BLOCK Z

Public Trust Meeting
BRE-BMR 8th LLC - Innov8

07/20/2023

design changes responding to agency comments

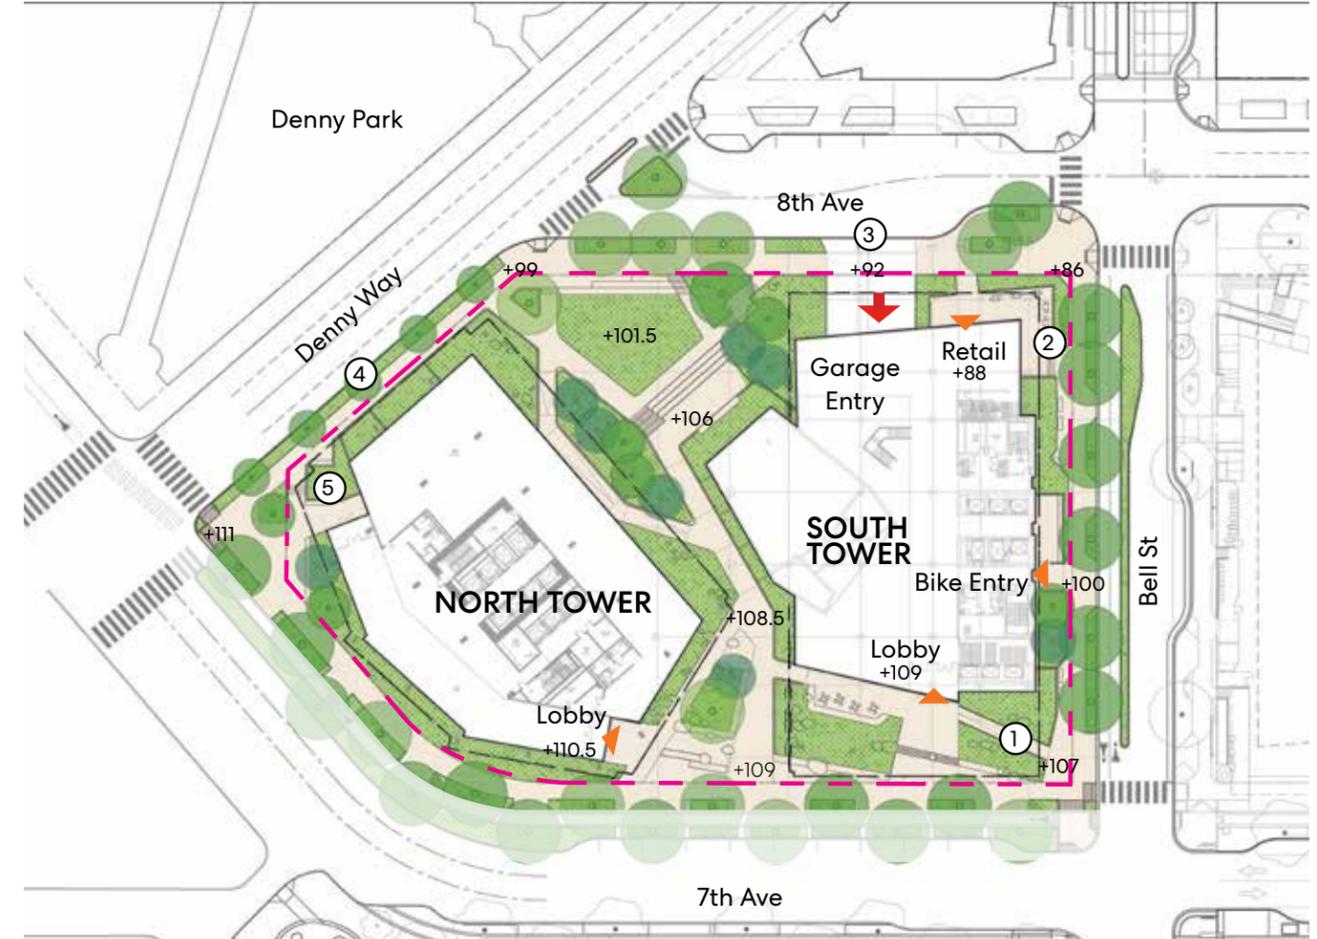
Summary of key issues identified by SDC (12012022 7th and Bell subcommittee notes)

- “Reconsider proposed improvement along Denny and 8th and refocus improvement along Bell, at and near site.”
- “Curbside management along 8th will be a challenge with limitations along remaining rights of way and garage access along 8th.”
- “Start engaging with SDOT to evaluate turning movements from Denny onto 8th and its impact on building access. Also look at nature of improvements at 7th and Denny.”

- “Create a connection at Denny and 7th to building through massing and ground level spaces.”
- “Pulling back of building and reorienting tower location at 7th and Bell would create an opportunity for better quality open space at SW corner of site, which will maximize sun exposure.”
- “Location and orientation of retail space should be reconsidered to maximize its impact on the public realm and open spaces.”

- ① The ground level facade at 7th and bell has been significantly pulled back to allow for more porosity, greater sightlines, and to expand the 7th Ave plaza space.
- ② Retail space is currently planned at the corner of 8th and Bell which creates a gateway to Bell st with the retail on the opposite side of Bell st. Additional retail spaces are being studied as part of the ongoing design.
- ③ The increased setback along 8th Ave improves sightliness and create a buffer zone at garage/ loading access.

- ④ The facade along Denny Way has been setback to allow for a greater landscape buffer and a more generous pedestrian experience along the busy street.
- ⑤ The ground level facade has been stepped back at Dexter and Denny to allow for better sightlines and pedestrian comfort. In addition a second entrance to the north building has been added to that corner to create a greater presence at the intersection

loading dock - vacation

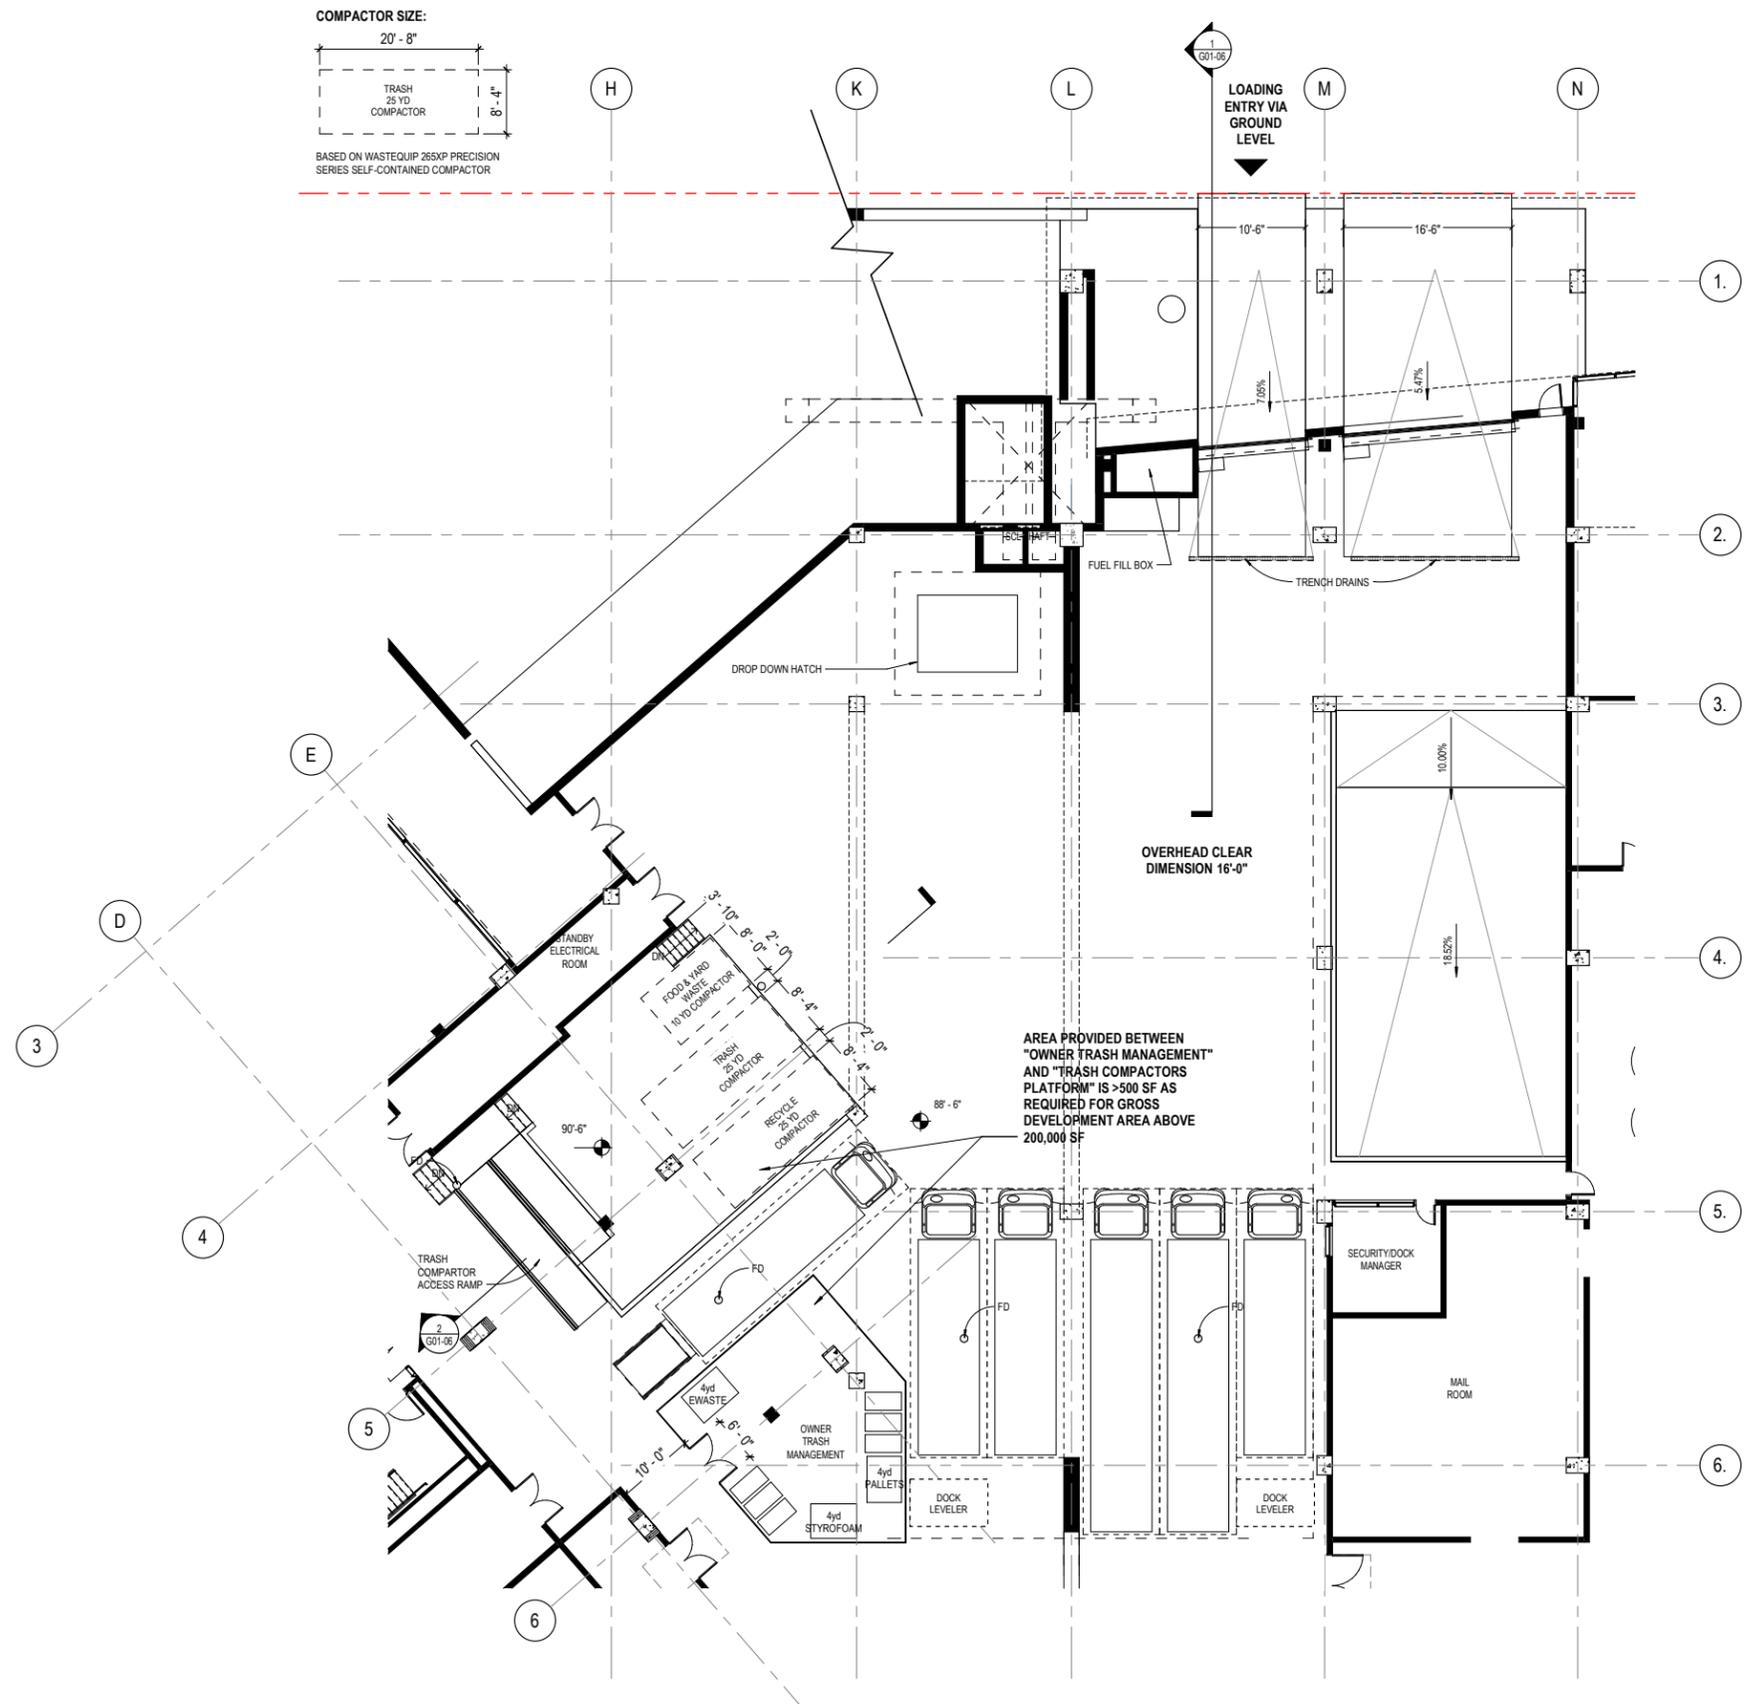
Review by Scott Clayton from SPU on 6/28/23.

No revision required by SPU. Under review by waste hauler. Final approval letter pending waste hauler approval.

Bell st and 8th ave

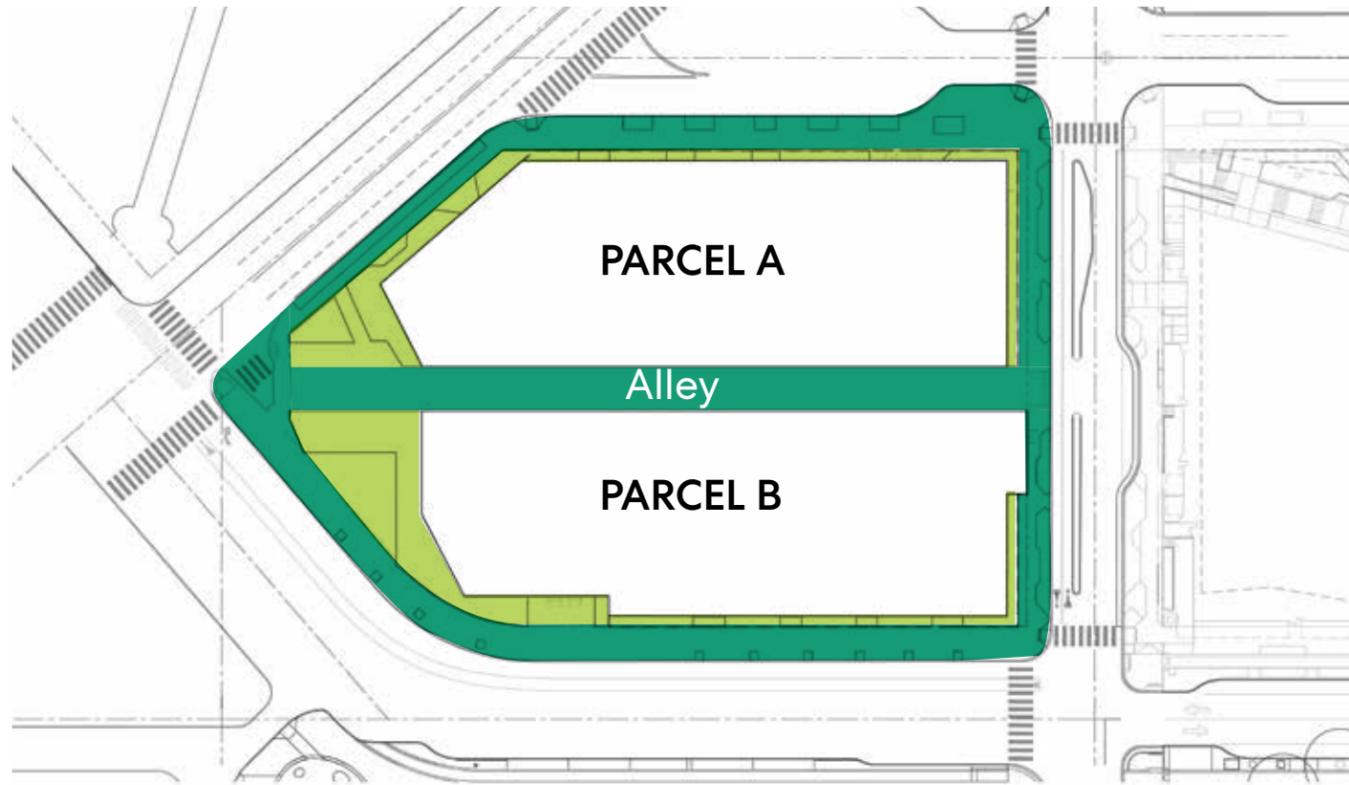
SDC Comment: location and orientation of retail space should be reconsidered to maximize its impact on the public realm and open spaces.

SDC Comment: Start engaging with SDOT to evaluate turning movements from Denny unto 8th and its impact on building access. Also look at nature of improvement 7th an Denny.

- Retail space is currently planned at the corner of 8th and Bell which creates a gateway to Bell St with the retail on the opposite side of Bell St. The inclusion of retail on this corner also knits the site to the retail pedestrian language on 8th Ave to the south of this project. Additional retail spaces are being studied as part of the ongoing design.

- The increased setback along 8th Ave improves sightliness and create a buffer zone at garage/ loading access.
